July 26, 2010

34, 3300, 48, 4700, TR

Improved design of the broom belt tensioner system on sweepers.

Broom Driver

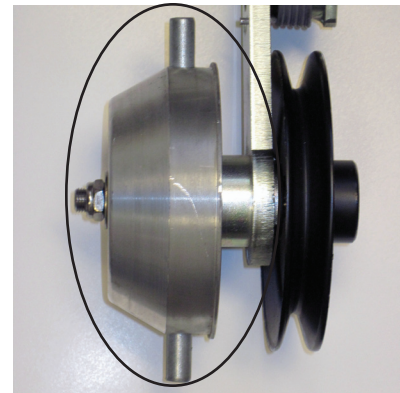
The Broom Driver has been reshaped to allow easier installation of the broom on the machine. In addition, the set screws for adjustable spacing are no longer needed as the broom driver to wall clearance is being more closely controlled in the manufacturing of the parts.

Tensioner Bearing

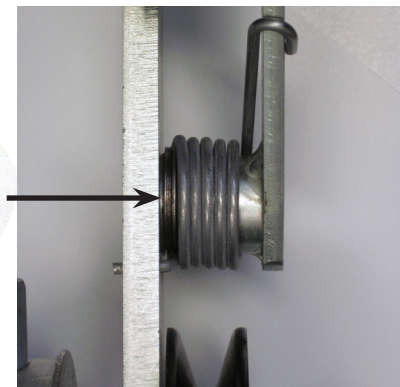
A bearing has been added to the friction point between the Tension arm and the broom arm to improve the tensioner performance. Previously there was no bearing in this location and it was just metal to metal contact.

Tensioner Mounting Bolt

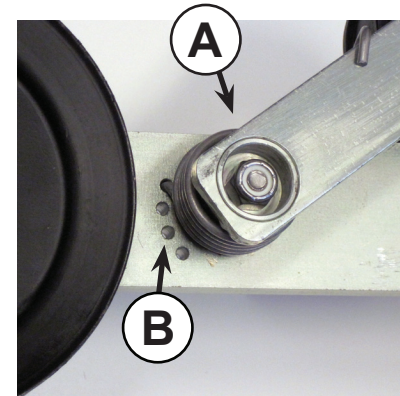
Tensioner removal and installation is made easier with a new tensioner mounting system. "A" This system eliminates the set screws on the tensioner bolt that were often forgot when the tensioner bolt was removed causing damage.

Tensioner Spring Mounting Holes

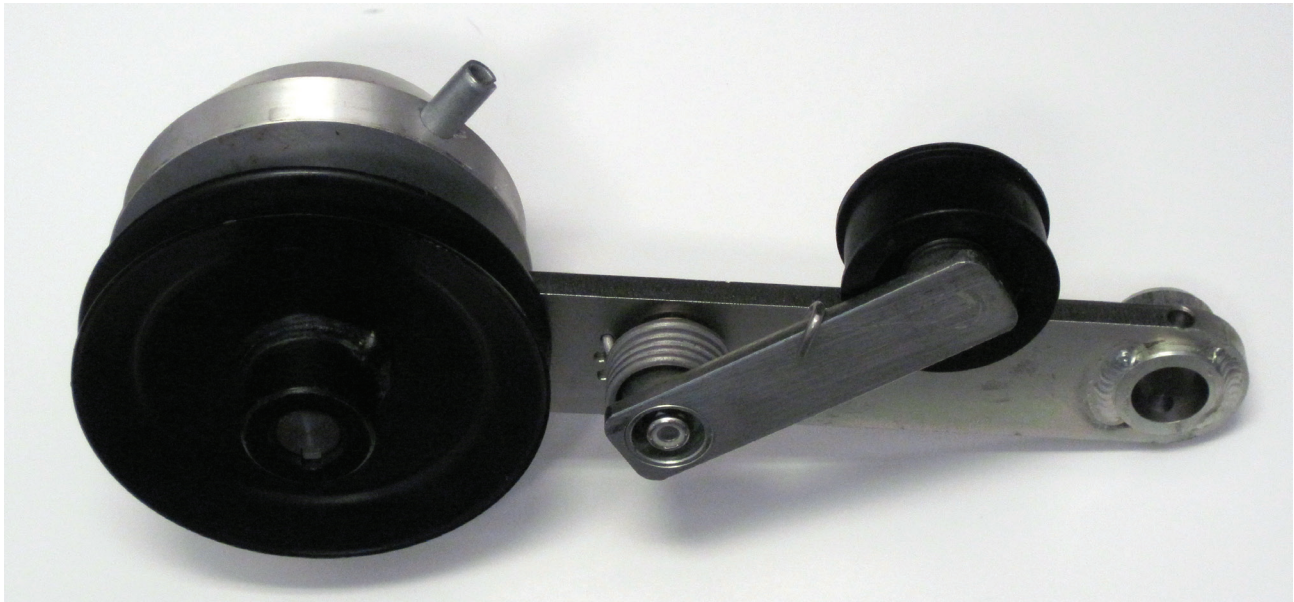
There have been an additional 3 holes added to the Broom Lateral Arm. "B" This accommodates a wider range of belt tension.
